Technical News Bulletin

Replacement of 555 Tube Height Jack

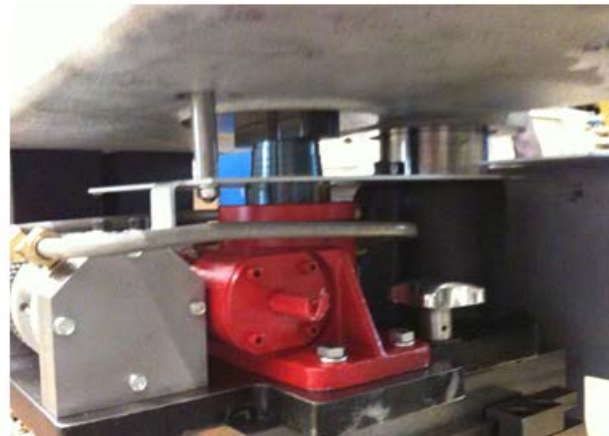
- Old Version tube height jack 59-17502-1 should be replaced with new version 59-17502-2.
- The new version of the jack has been used in production of 555 feeder tube height adjustment mechanisms.
- Modifications are required to fit the new Component.

Owing to the obsolescence of commercial component as shown (Old Version tube height jack 59-17502-1), there has been a necessity to replace this with new version 59-17502-2. **Modifications are required to fit the new Component.** The new version of the jack has been used in production of 555 feeder tube height adjustment mechanisms from 3rd quarter of 2008 and is clearly identifiable with the silver color instead of the original red color.

The new jack 59-17502-2 requires a larger hole in the tube holder and the support plate it can not be replaced without the modifications to these parts prior to the modifications to the parts as shown on the attached drawings. There is also a conversion kit of parts 59-17502-3. This includes the new Jack screw and the required mounting parts as listed below.

59-17502-1 Old version of jack **RED**
59-17502-2 New version of jack **Silver**
59-17502-3 Conversion of old to new jack including mounting parts - alteration is required
